Iso Booster fixture status 22 June 2016

ISO/CD 13216-3 CD Ballot results

Agreed proposal

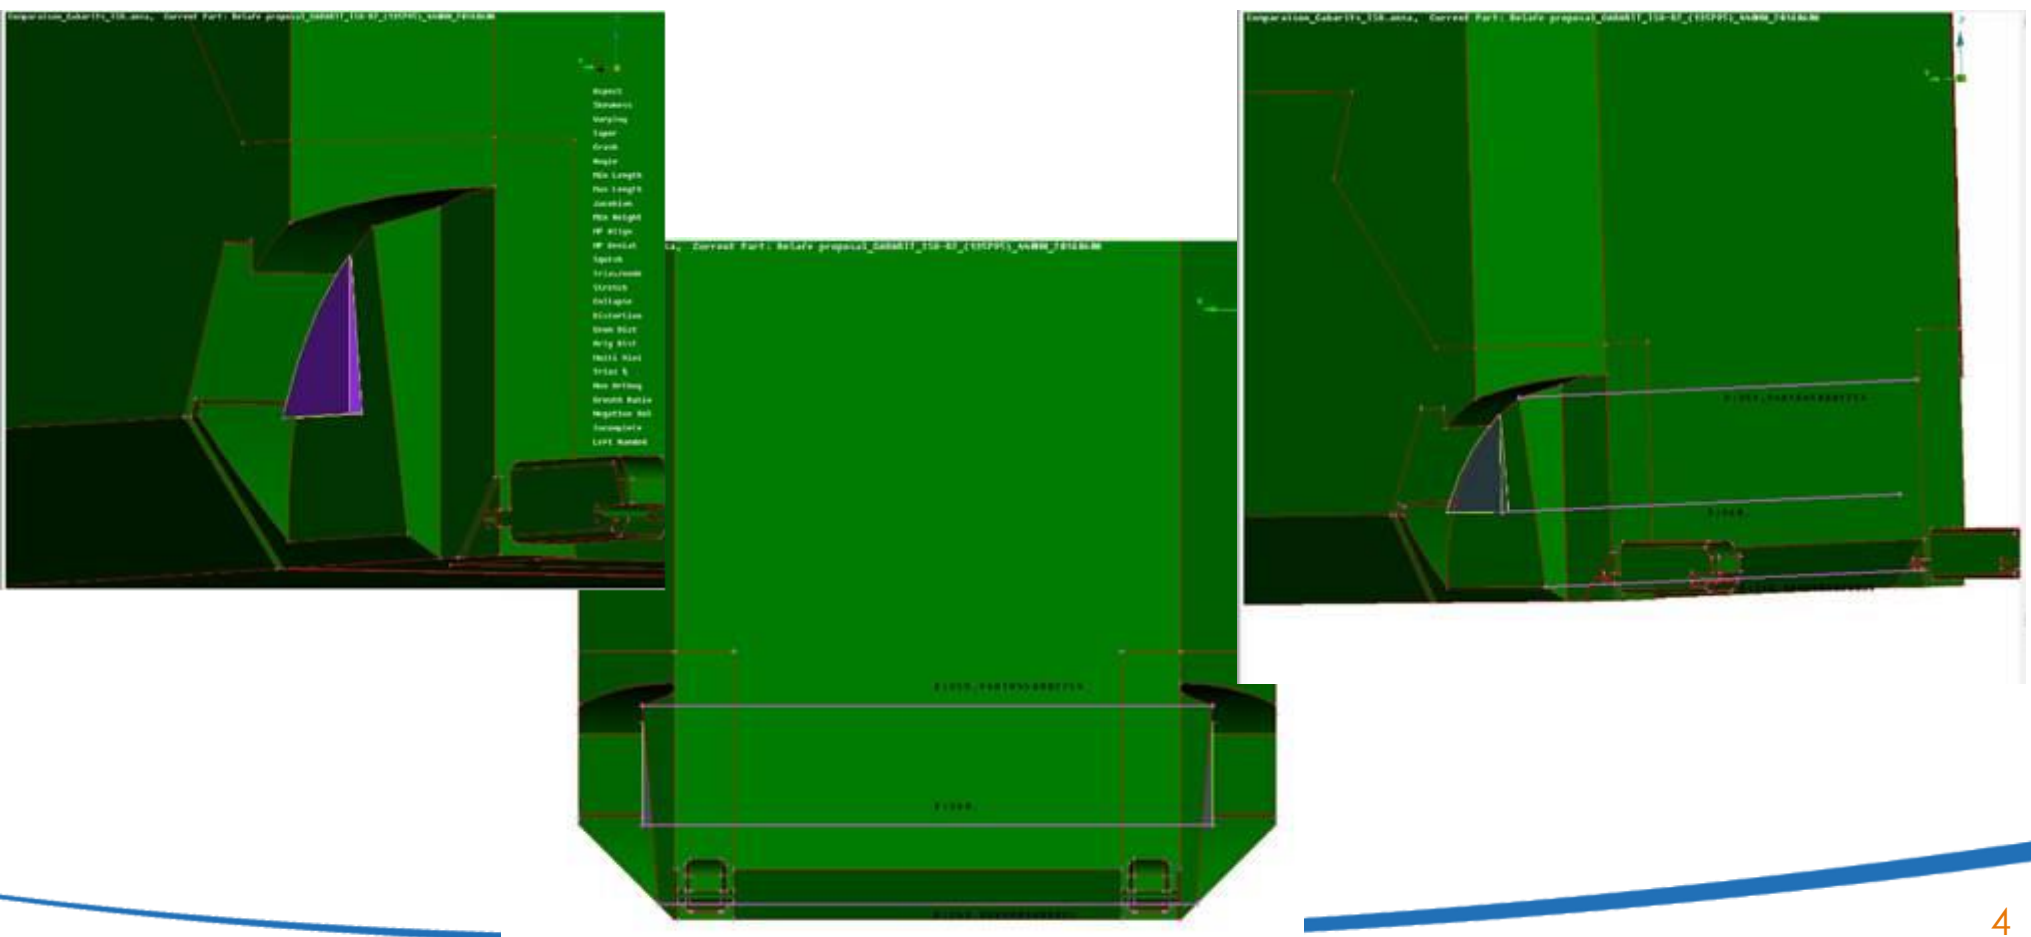
Comments from France

- Potential interference with the buckling area

- Leave accessibility to the buckle preserving volume needed for CRS
